TO: Mercedes-Benz Dealer Principals, General Managers, Sales Managers,	FROM: Gregory Gunther, Department Manager, Vehicle Compliance and
Service Managers, Parts Managers	Analysis, Engineering Services
RE: Recall Campaign Launch Notification	
Mounting of A/B/C pillar covers	DATE: September 10, 2019
MY19 222 (S-Class)

Campaign No. 2019080006, September 2019

SUBJECT: Model S-Class vehicles, (222 platform)

Rework torque of A-, B-, and C-pillar trims, as well as wheel arch liners

Figure 3

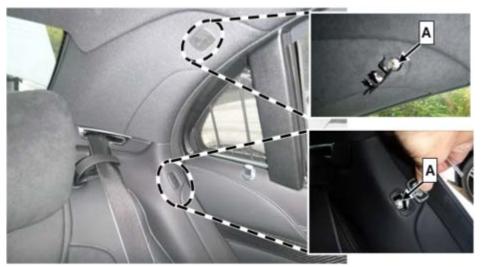
3. Remove SRS cover on C-pillar and wheel arch and correct torque (Mm 5) (A, Figure 3).
